PETITION NO: Z-108

PROPERTY LOCATION: Located at the north westerly intersection of
Woodland Brook Drive and the CSX Railroad tracks, the north and south
sides of Heavenly Trail, east of Paradise Shoals Road and on the easterly and
westerly sides of Paradise Shoals Road, north of the CSX Railroad tracks.

PLANNING COMMENTS:

Planning Staff Analysis

DEVELOPMENT SUMMARY

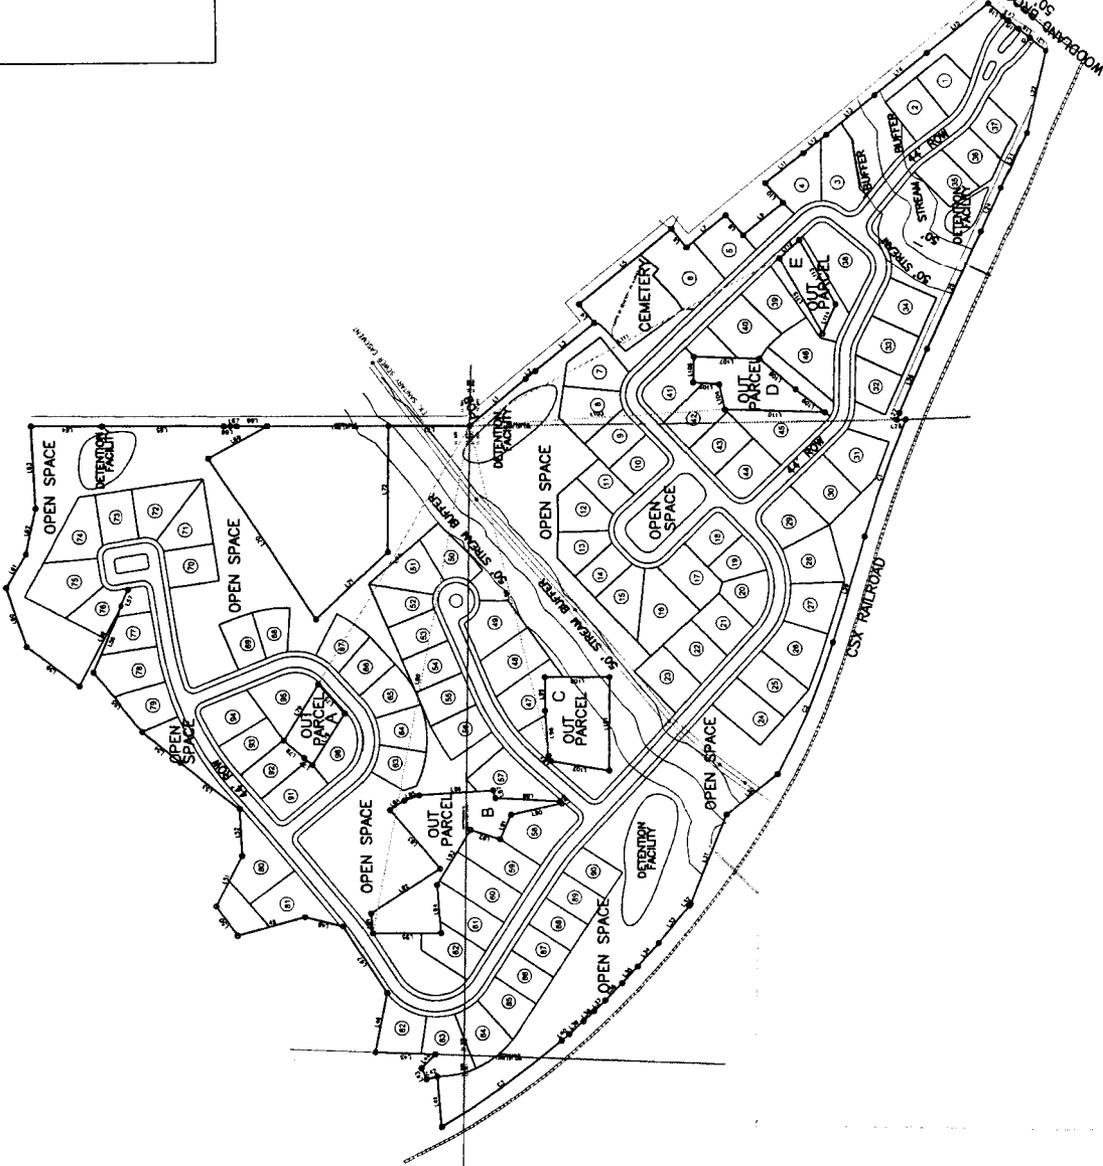
2. Under the Open Space Plan guidelines the plan must limit development to slopes less than 25%. Most of the steeper portions of the site have been placed in the open space. However, several lots appear to be located on slopes greater than 25% (Lots 7, 13, 26, 73 -76, 63-65 and 89). A detailed slope analysis should be performed to accurately identify site areas with slopes greater than 25% and a revised plan prepared. Also, all of the proposed detention facilities are shown to be included in the open space. These ponds must be placed on separate parcels with flagged access to the public right-of-way and should not be included in the open space calculations.

3. The number and size of the proposed detention ponds appears inadequate for the size and intensity of the proposed development. Additional area will likely be required to meet stormwater quality and quantity requirements.

1. Maximum density with bonus exceeds the maximum density recommended for the property by the county comprehensive plan and future land use map. Reduce density to 2.0 units per acre or reduce lots to 85 units.
2. Minimum setback requirements as well as lot sizes for each lot shall be listed as notes on concept plan as well as a minimum lot size for the overall development.

3. Overall development must be compatible with neighboring residential uses. Concept plan should incorporate larger lots on the northeast property line. This would affect lots 1-7. Also, rear setbacks on these exterior lots must be equal to or greater than adjacent, existing lots.

4. Contiguity of open space is highly desirable and must be at least 25' in width. Open space behind lots 26 & 27 should be widened and open space between 65, 66 & 54, 55 should be added in order to meet the intent of the contiguity requirement.

6. Limits of grading on each lot should be detailed to avoid clear cutting of lot during site preparations
7. The proposed stormwater management areas must be on dedicated lots and the acreage of each must be subtracted from the open space totals because it will be in an area that is disturb and does not meet the conservation goals of permanently protected open space. This will reduce the acreage contained in the existing open space calculations unless other site changes or made. If stormwater management areas are already subtracted then note the calculations on concept plan. (concept plan is unclear regarding the inclusion of stormwater management areas in open space acreage totals)

8. The locations of 3 of the 4 stormwater management areas are in an area with substantial tree growth. The locations of 2 of 4 stormwater management areas are located adjacent to stream buffers. This has the potential to negatively impact the existing natural hydrologic systems on this property. The stormwater management areas should not be located in a place that can have this type of negative impact on streams and existing waterways.

10. Slopes greater than 25% must be included in the required open space. Based on GIS slope analysis, this would include parts of lots 7, 8, 13, 21, 22, 23, 24, 26, 27, 28, 32, 39, 55, 56, 60, 61, 64, 65, 71, 73, 75, 76, 88, 89, 91 & 93. Also, detention facility behind lots 7 & 8 must be relocated off of slopes greater than 25%.

11. Out-parcels A, B, C, D & E must have 75' of public road frontage or at least 50' of road frontage at cul-de-sac. Applicant should find a way to incorporate out-parcels into proposed R-15/OSC development.
